Subject: **PSEG Early Site Permit Application**
Docket No. 52-043
Response to Request for Additional Information, RAI No. 62, Gaseous
Waste Management System

- Enclosure 1: Response to NRC Request for Additional Information, RAI No. 62,
Question No. 11.03-9, SRP Section: 11.03 – Gaseous Waste
Management System
- Enclosure 2: Proposed Revisions Part 2 – Site Safety Analysis Report (SSAR), Chapter
11 – Radioactive Waste Management
- Enclosure 3: Summary of Regulatory Commitments

Response to RAI No. 62

Question No. 11.03-9

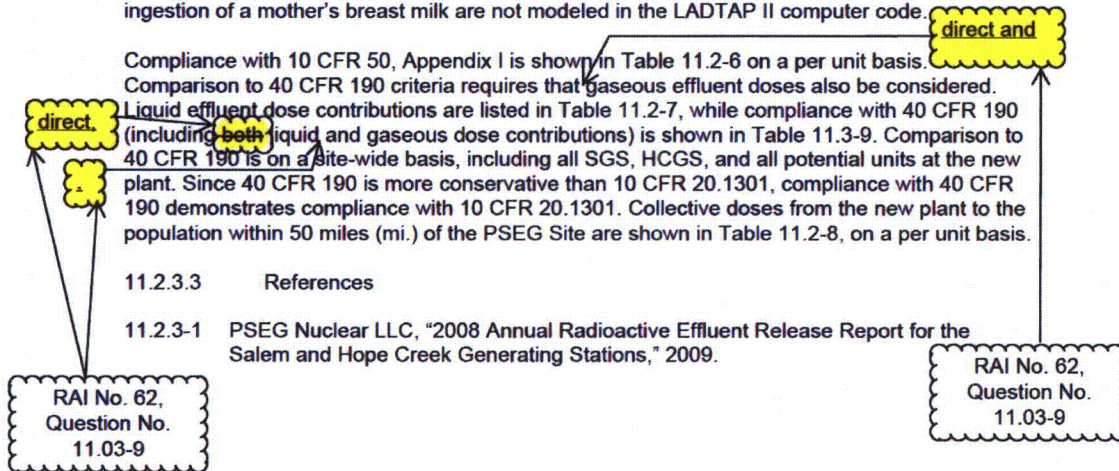
In review of SSAR, Table 11.3-9, the staff has determined that direct doses are not included anywhere in this table to show compliance with 40 CFR 190 and 10 CFR 20.1301(e).

The staff would like to know if the required information has been provided elsewhere in the SSAR, and if so, where. If not, the staff requests that the applicant include direct radiation doses in Table 11.3-9 as part of compliance with 40 CFR 190 and 10 CFR 20.1301(e), and provide a mark-up of the SSAR changes with the response, or justify why direct doses from all fuel facilities on site do not need to be considered.

The direct radiation dose to the public, for each reactor technology, is discussed in their associated Design Control Document (DCD). The direct doses for the AP1000 and US-APWR are negligible. The direct dose for the U.S. EPR (<1 mrem/year) is for a location at the exclusion area boundary of 0.5 miles. The direct dose for the ABWR (<2.5 mrem/year) is for a Maximally Exposed Individual (MEI) outside of the controlled area. The doses associated with these two locations are assumed to be applicable to the 40 CFR Part 190 MEI dose analysis at the PSEG Site. This assumption is acceptable because the 40 CFR Part 190 MEI at the PSEG Site is located at the nearest residence (2.8 miles from the site). The nearest residence is farther away from the site than the direct dose locations for the ABWR and U.S. EPR, and the specified direct dose values for these reactor technologies bound the associated direct dose values at the nearest residence.

The direct dose for the ABWR is greater than the direct doses for the other technologies and is therefore used as the bounding value for the PSEG Site. Note that a dual unit plant is also considered at the PSEG Site, but this scenario is limited to only using two AP1000 units. Since the direct dose for a single AP1000 unit is negligible, the direct dose for a single ABWR unit is greater than the direct dose for two AP1000 units and hence is a bounding value for all reactor technologies considered for the PSEG site.

Note that the direct dose for the ABWR, 2.5 mrem/year, is based on a limit with respect to minimal plant shielding design and is a highly conservative estimate for direct radiation at the PSEG Site. This conservative shielding assumption is why the assumed 2.5 mrem/year MEI value is much greater than the actual measured total dose due to operation of the existing Salem and Hope Creek units. Table RAI-062-1 provides a comparison of the direct, liquid and gaseous dose contributions assumed for the PSEG site to the 40 CFR 190 Criteria.

SSAR Table 11.3-9 will be updated as specified in Enclosure 2 of this document. In addition, associated text changes are made to SSAR Subsections 11.2.3.2, 11.3.3.2 and SSAR Table 11.2-7, as specified in Enclosure 2 of this document.
